AGENDA
CITY OF CREVE COEUR
PLANNING AND ZONING
300 NORTH NEW BALLAS RD
OCTOBER 2, 2023
6:00 PM

**APPLICATIONS TO PLANNING AND ZONING COMMISSION
#23-027 AND #23-028: FOR A REZONING FROM “RO” RESEARCH
OFFICE DISTRICT TO THE OLIA VILLAGE “PMD” PLANNED MIXED-
USE DEVELOPMENT DISTRICT WITH A SITE CONCEPT PLAN, PHASE
ONE SITE DEVELOPMENT PLAN AND ASSOCIATED PRELIMINARY PLAT
FOR THE 96 ACRE PROPERTY AT 10300 OLIVE BOULEVARD**

REVISED PLANS SUBMITTED IN RESPONSE TO SEPTEMBER 18TH P&Z REVIEW

Figure 3: Sheet C-108 Pedestrian Plan showing revised location of shared use path around northern portion of Lot 7

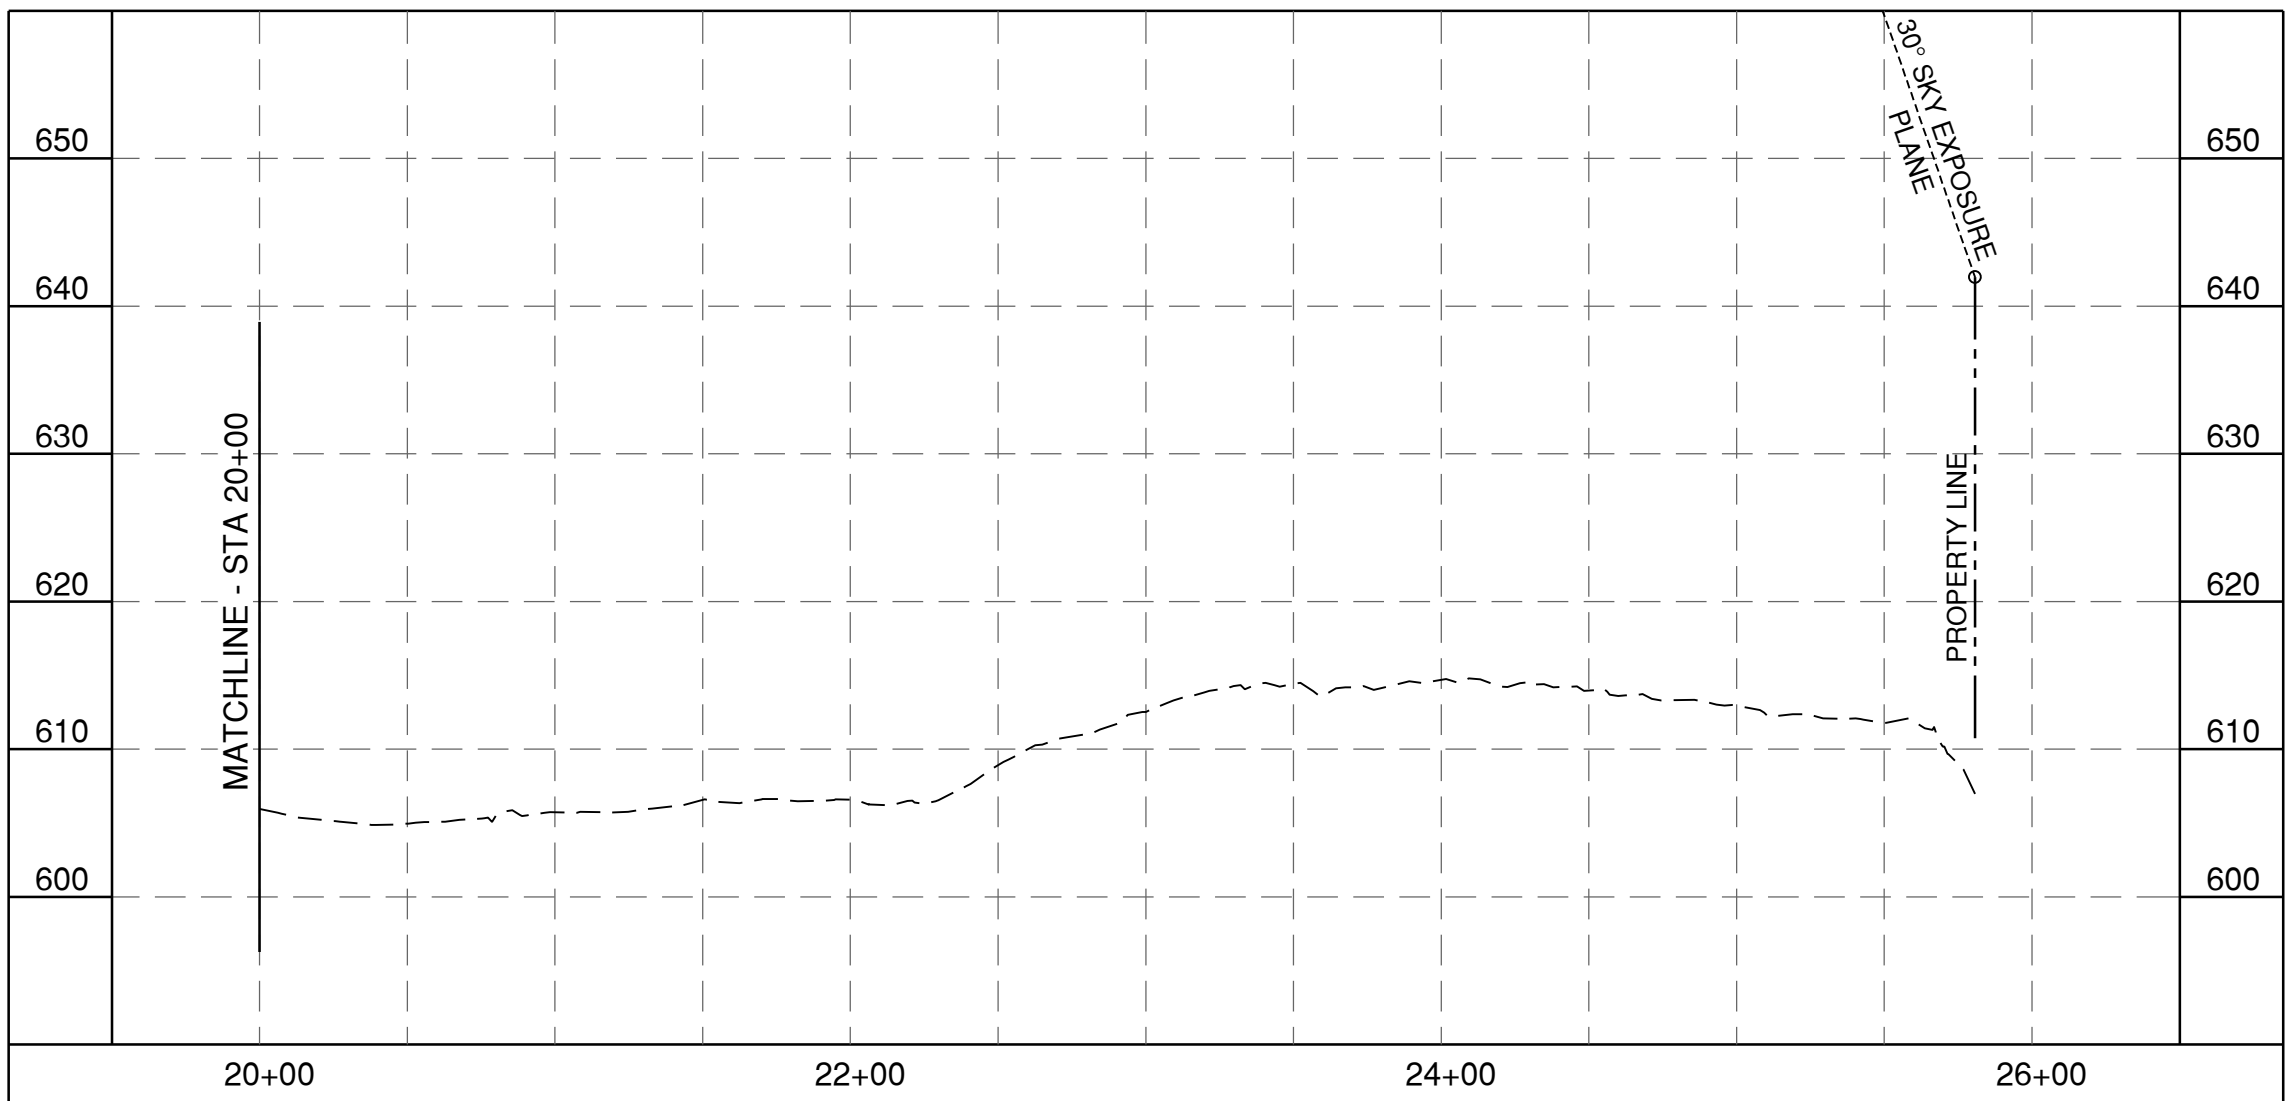
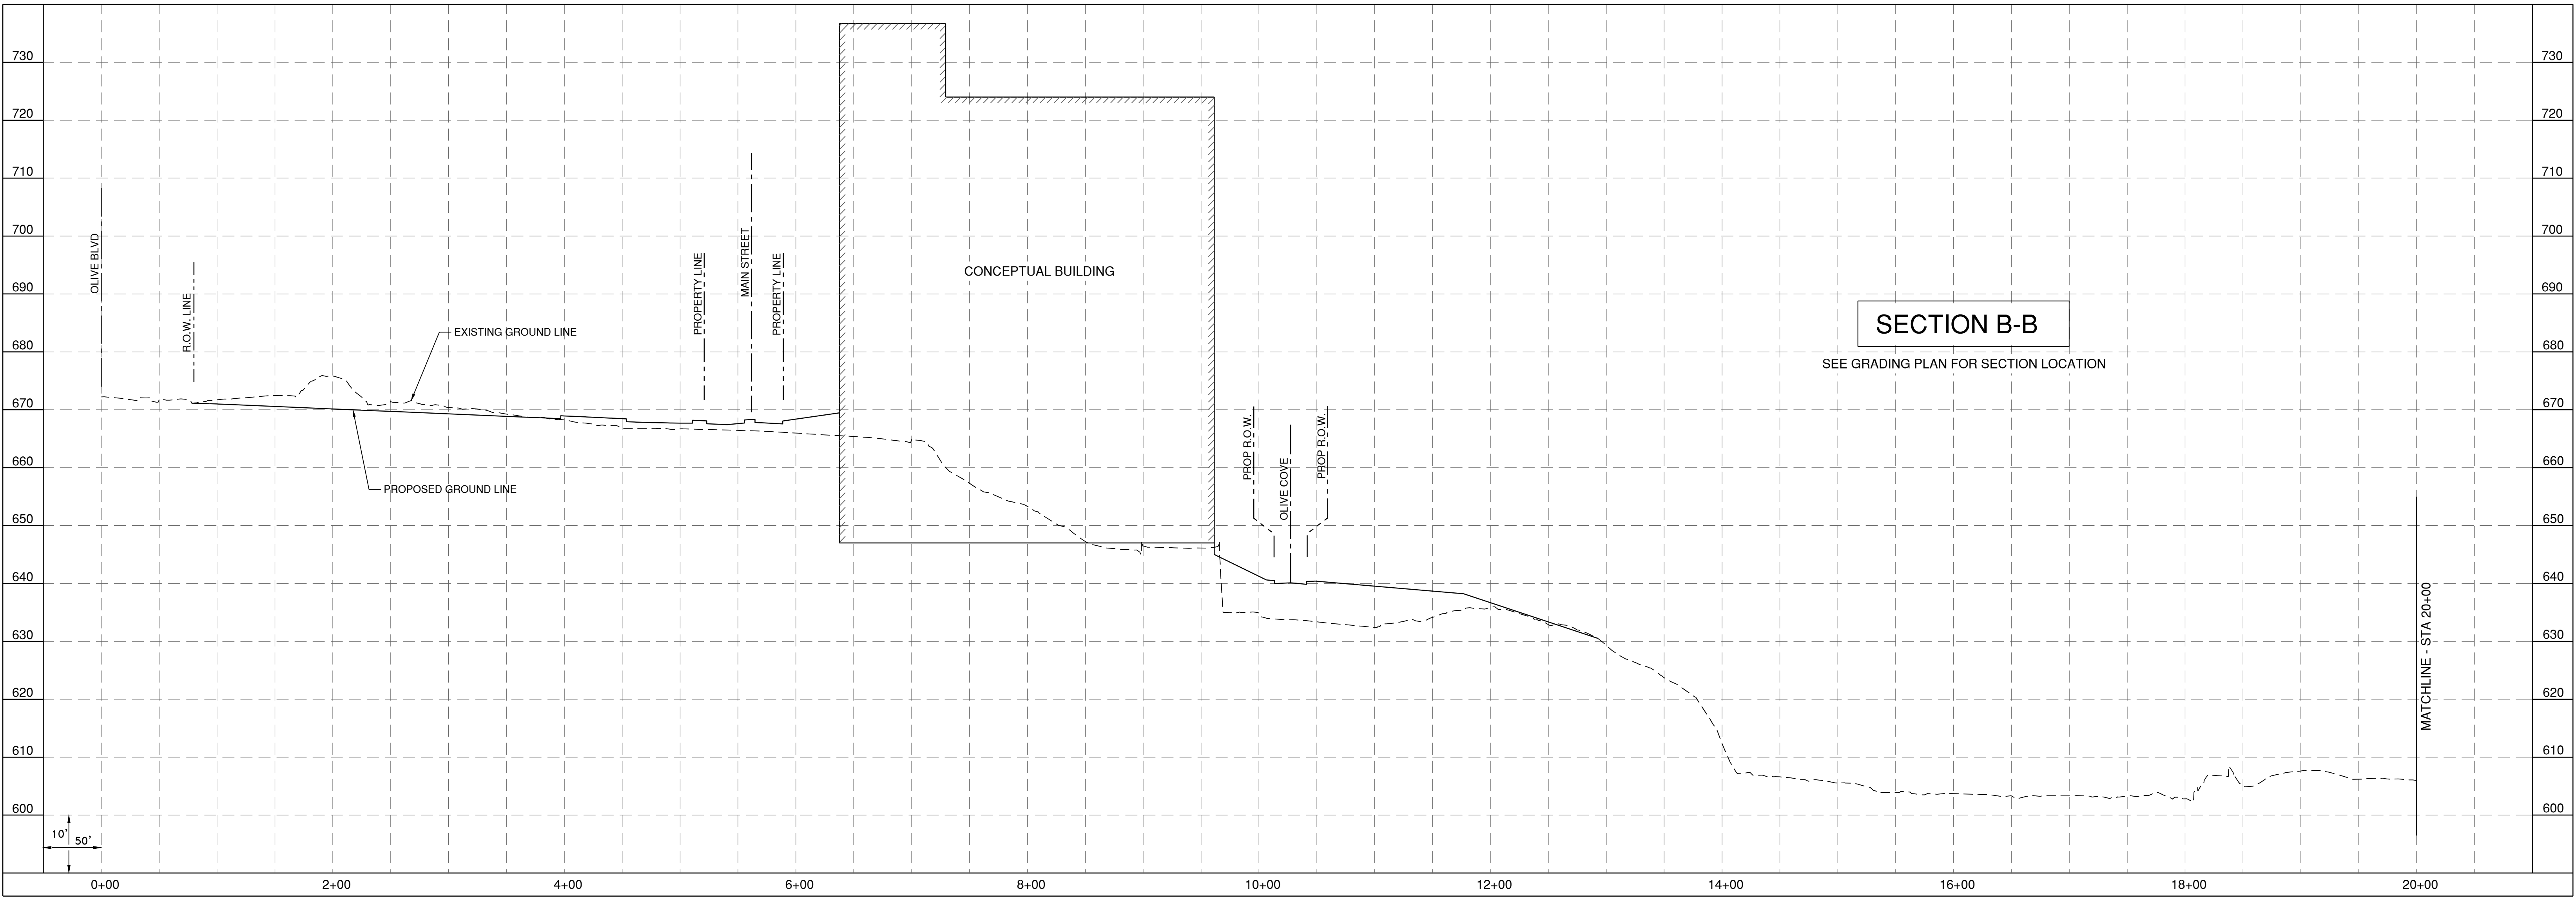
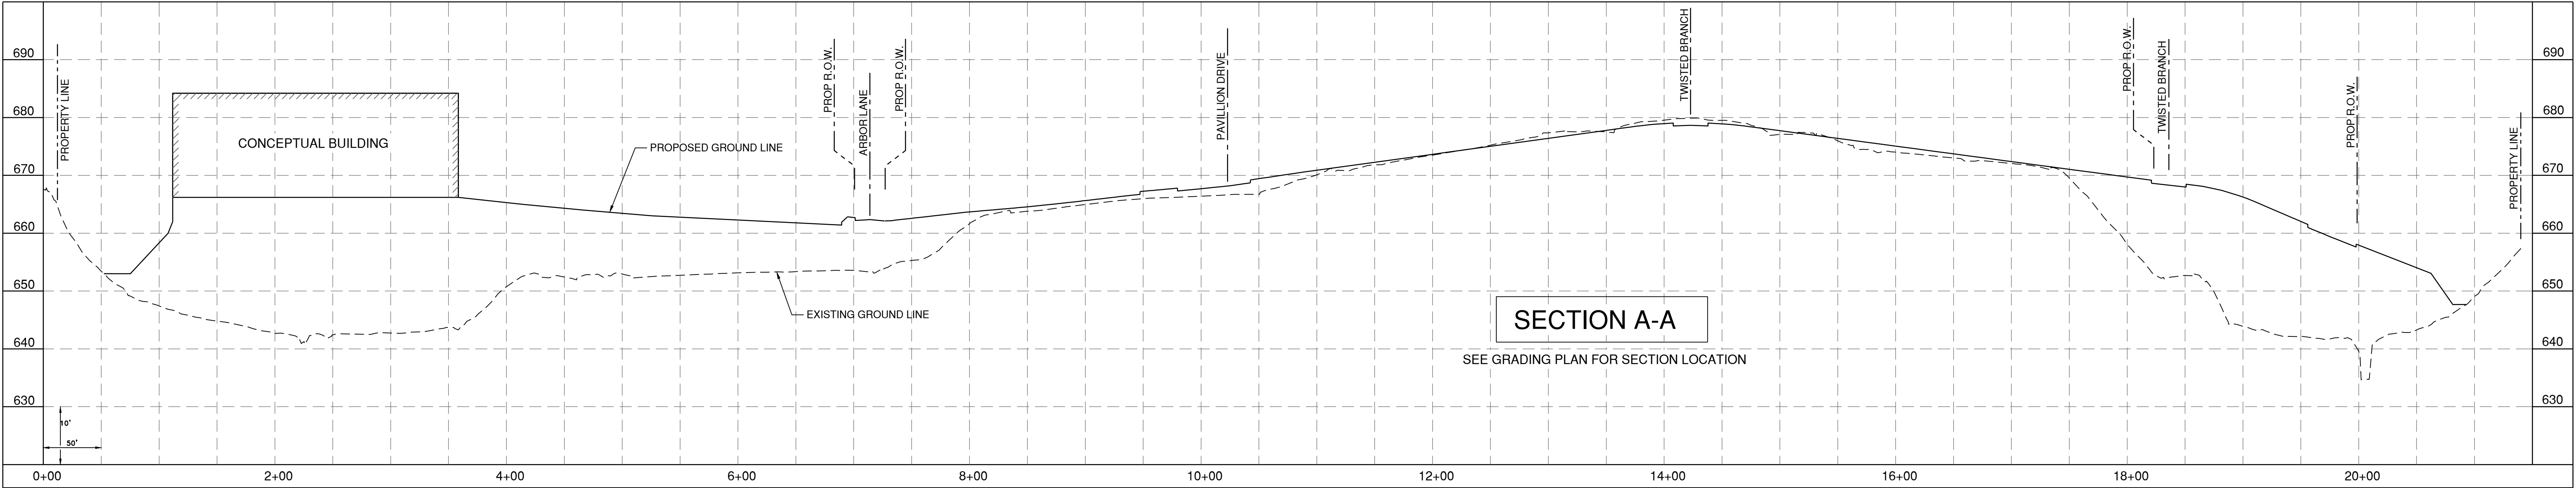
The Pedestrian Plan on Sheet C-108 was revised to show the new location of the shared use path throughout the site including the new orientation of the path around the outside of Lot 7 adjacent to Twisted Branch road following comments from Staff. Staff was concerned that the previous location of the 8-foot-wide shared use path in front of the building along Main Street would be disruptive to an active, walkable streetscape. The applicant has addressed this concern by rerouting the shared use path along the northeastern edge of Lot 7 instead. The sidewalks along Main Street, within the Main Street district between Arbor Lane and Twisted Branch, now provide an unobstructed 8 feet wide path. The angled on-street parking stalls were shortened from 21 feet to 19 feet to accomplish this. The rest of the sidewalks in the Main Street district will be a minimum of 7 feet wide. Public restrooms for the Main Street district, park area and shared use path will be available in the leasing office on Lot 4 adjacent to the garage entrance at the end of Pavilion Drive and immediately southeast of the park area.
